7.2.4.6 Carrier Sense function⁸

Comment Number: 1, from SC6 N10 037
Comment Type: Editorial
Section/Clause/Page: Figures 7-7
National Body Concern: The rationale for the revision to Figure 7-7 is given as 'to correct an editorial error'. The change is considerably more than editorial as it changes a 5-state diagram to a 3-state diagram, as well as other changes. A proper rationale is required by Member Bodies so that they can understand the need for and the implications of this change-The UK requires a proper explanation of this change so that it can decide whether or not it should be approved.

Figure 7-8—PLS Carrier Sense function*

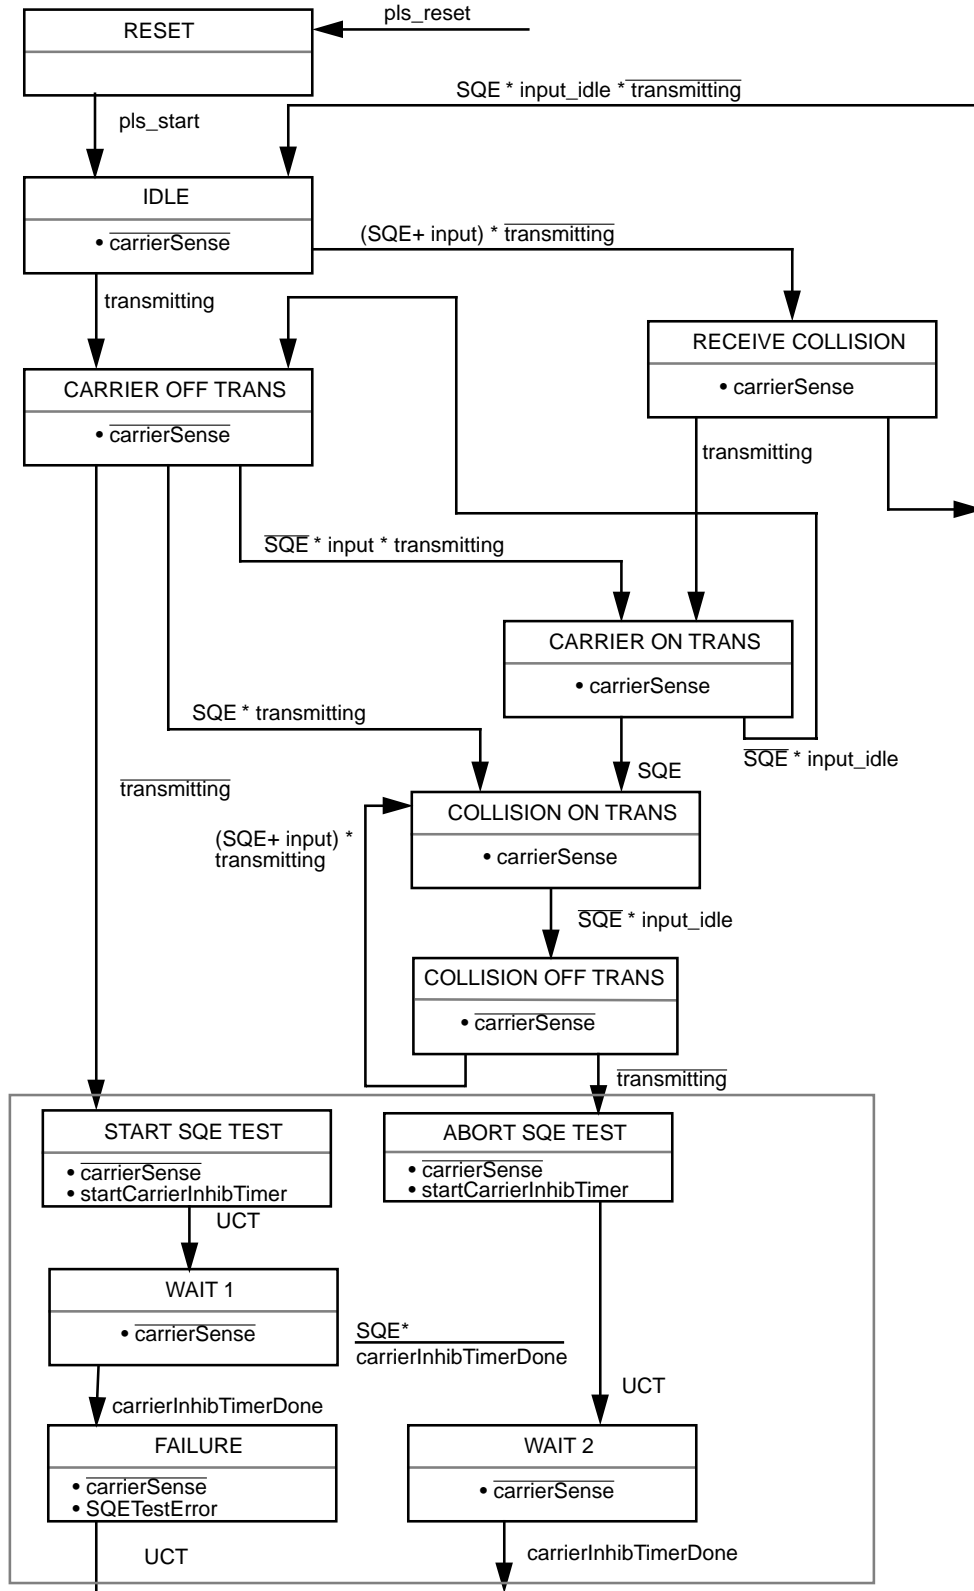
Comment Number: 3, from SC6 N10 037
Comment Type: Editorial
Section/Clause/Page: 7-2-4.5, 7.2.4.6., Figures 7-7, 7-8
National Body Concern: The changes to the wording of subclause 7.2-4.5 and 7.2-4.6 and in Figures 7-7 and 7-8 are incorrect in terms of the descriptive model defined in subclause 7.2.2 for use in Clause (chapter) 7 (PLS) for the communications between the MAC and PLS. The term 'collisionDetect', 'carrierSense' and 'transmitting', which are used in the new text of these subclauses and Figures, are from the descriptive model defined in subclause 4.3.3 and used in Clause 4. The UK requires the consistent use of the descriptive model in Clause 7 before it will change its response to approve.

Comment Number: 4, from SC6 N10 037
Comment Type: Editorial
Section/Clause/Page: 7.2.4.5, 7.2.4.6
National Body Concern: ISO/IEC 8802-3 adopts a consistent style in referring to actions involving signals, messages and the Pascal program elements of Clause 4. Binary signals are asserted and negated (or de-asserted), messages are sent and received, the value of a Pascal program variable is set (if it is a Boolean variable, it is set to true or false). The new text of subclause 7.2.4.5 and 7.2.4.6 does not follow this style. For example in 7.2.4.5, there is the text '...the task of sending collisiondetect to the MAC sublayer ...' but collisiondetect is defined in Clause 4 as a Boolean variable and cannot therefore be sent. Similarly for carriersense in 7.2.4.6. The UK requires that the consistent style be used for the replacement text and figures before it will change its response to approve.

Comment Number: 9, from SC6 N10 037
Comment Type: Editorial
Section/Clause/Page: 7.2.4.5, 7.2.4.6, Figures 7-7, 7-8

Note to be added to 7.2.2.1.4 CARRIER_STATUS

Note- Formely, the carrier Sense function described in Figure 7-8 generated the CARRIER_STATUS message described above. For the sake of consistency with common implementation practice, the variable carrierSense is generated directly by the Carrier Sense function in recent editions of the standard. The mapping between the CARRIER_STATUS message and the CarrierSense variable is as follows. When the carrierSense variable changes from False to True, the CARRIER_STATUS message is sent with the parameter CARRIER_ON. When the value of the carrierSense variable changes from True to False, the CARRIER_STATUS message is sent with the parameter CARRIER_OFF.

Similar notes will be provided for SIGNAL_STATUS (7.2.2.1.5) and output_in_progress.
